## Product Change Notification

Product Name : Liquid leak sensors

Series Name : WL10 series

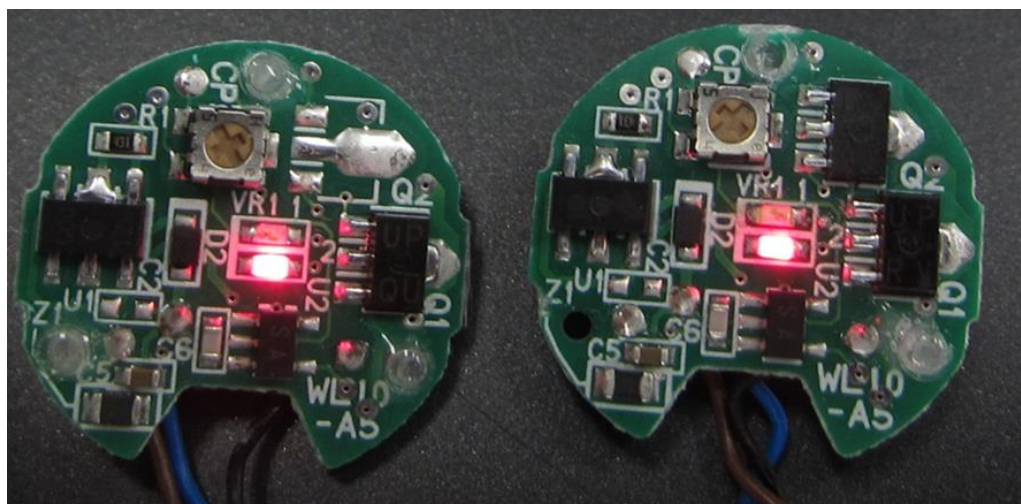
The Red LED that is used to show leak-detection will change (component change).

Before the change	After the change
Manufacturer	Kingbright Electronics Co. Ltd.	
Part number	<i>KPT1608LSRW-PRV</i>	<i>KPT1608LR01C-KL</i>

They are generally equivalent to each other in basic characteristics, apart from the level of luminous intensity. By changing the level of current on the circuit, the luminous intensity of the replacement will be the same as that of the current LED. There are no specifications changes to these liquid leak sensors.

The level of luminous intensity of the replacement is equivalent to that of the current LED.
